# City of Detroit

**RE:** Request of the Detroit Regional Convention Facility Authority to show a PC (Public Center) zoning district where a B5 (Major Business) zoning district is currently shown on two parcels commonly known as 560 and 580 Civic Center Drive. Additionally, a PC District review of a proposed addition to the Huntington Place Convention Center.  
**(RECOMMEND APPROVAL – ORDINANCE INCLUDED TO SET A PUBLIC HEARING)**

RE: Public Center (PC) review of the proposed Skybridge Connector at Huntington Place

*Rendering of proposed addition to Huntington Place – looking east along Civic Center Dr.*

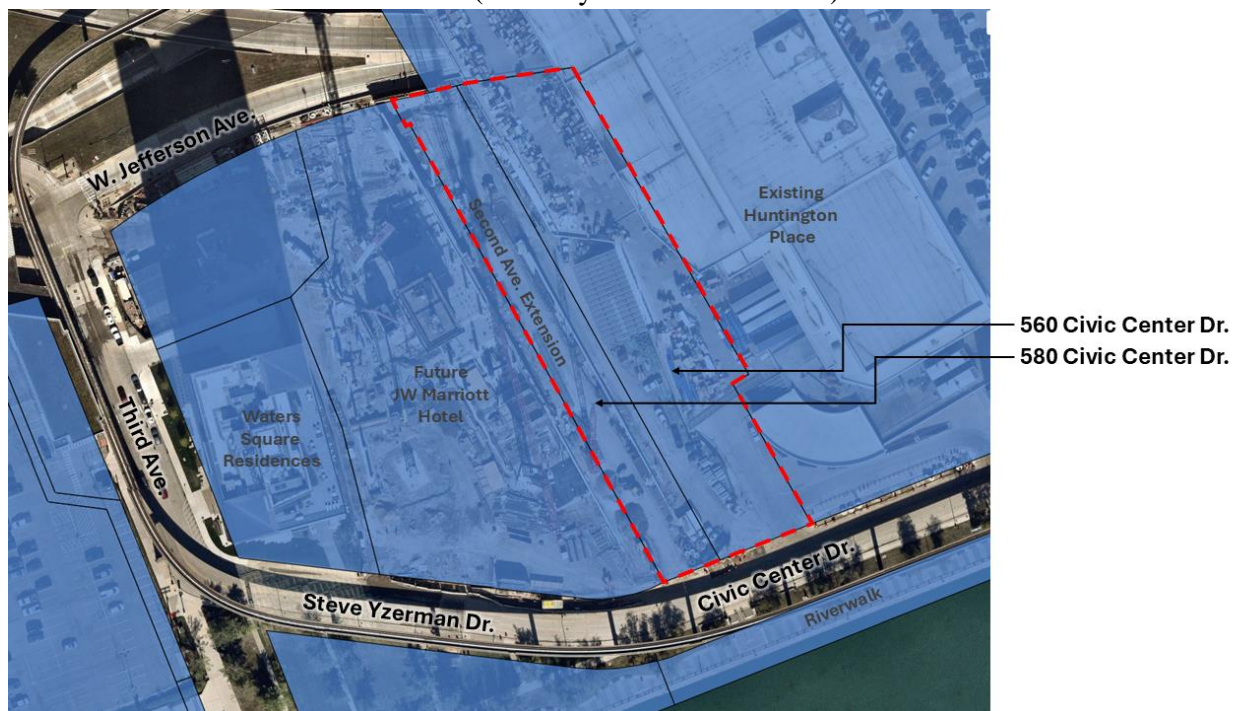
The Planning & Development Department has reviewed the proposed plans for the addition and has recommended approval. They made one suggestion—that the dark gray corrugated metal panels proposed for the north façade may look too dark as a result of shadows and a lighter color may be advisable. The full review is attached for reference.

*Given the shadows created by the corrugated metal and the dark color, a lighter color may be advisable to avoid the wall looking black.*
